**re: Geotechnical Review – Site Servicing Plan**  
Proposed Mix-Use Development  
1131-1151 Teron Road - Ottawa

**file:** PG5283-MEMO.03

### **Site Servicing Plan Review**

**SERVICE PROTECTION  
PLAN**

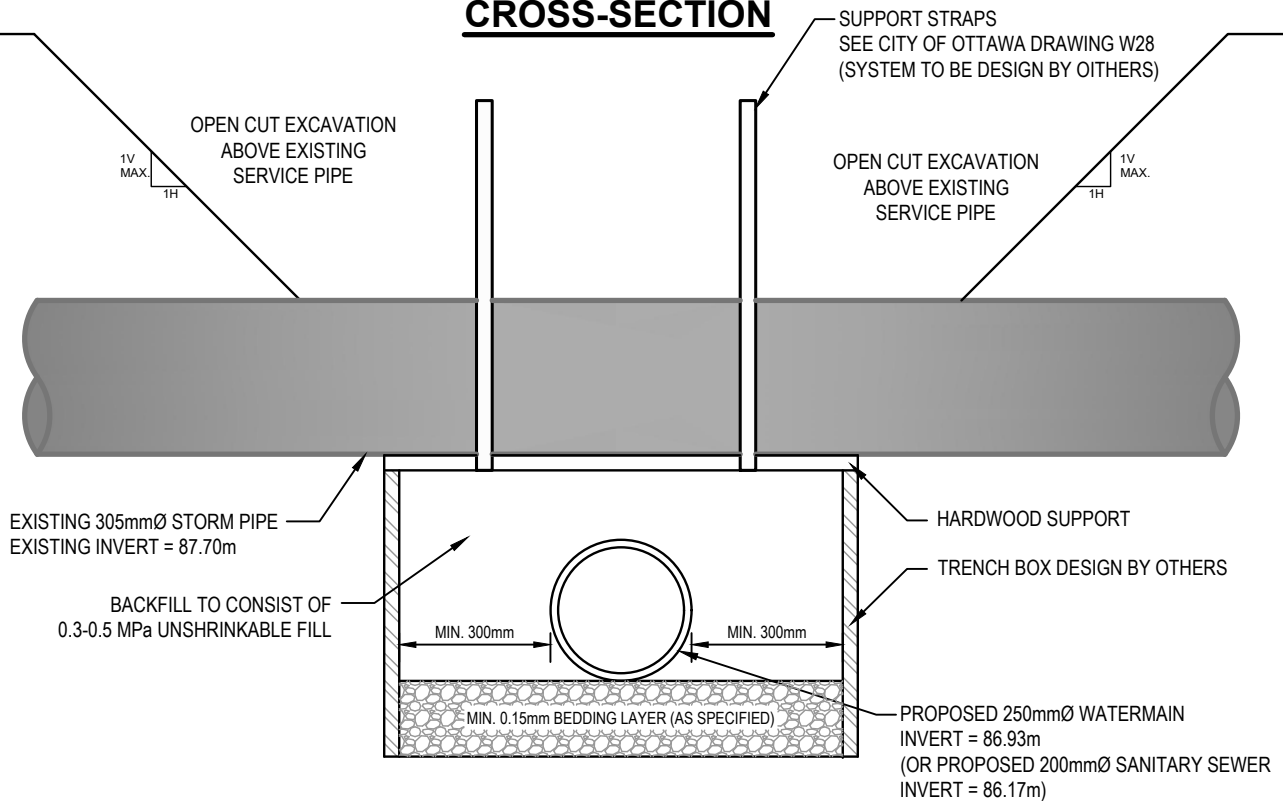
- The excavated area below the existing storm sewer and watermain should be reviewed by the geotechnical consultant and backfilled with an unshrinkable fill (0.3 to 0.5 MPa - compressive strength). The unshrinkable fill should in-fill the excavated area adjacent to the installed watermain/sanitary sewer and extend vertically to the invert level of the existing storm sewer and watermain pipe and horizontally to the supported sides of the excavation. Furthermore, the unshrinkable fill shall extended horizontally beyond the face of the existing service pipes a minimum distance of 300 mm. The unshrinkable fill should be placed against a clean, excavation sidewall face to eliminate any voids that may cause settlement issues.

- Figures 1 attached present the service protection plan details for the unshrinkable fill at the service crossing areas. The remainder of the excavated trench outside the vicinity of the pipe crossing points can be backfilled with typical pipe backfill materials.
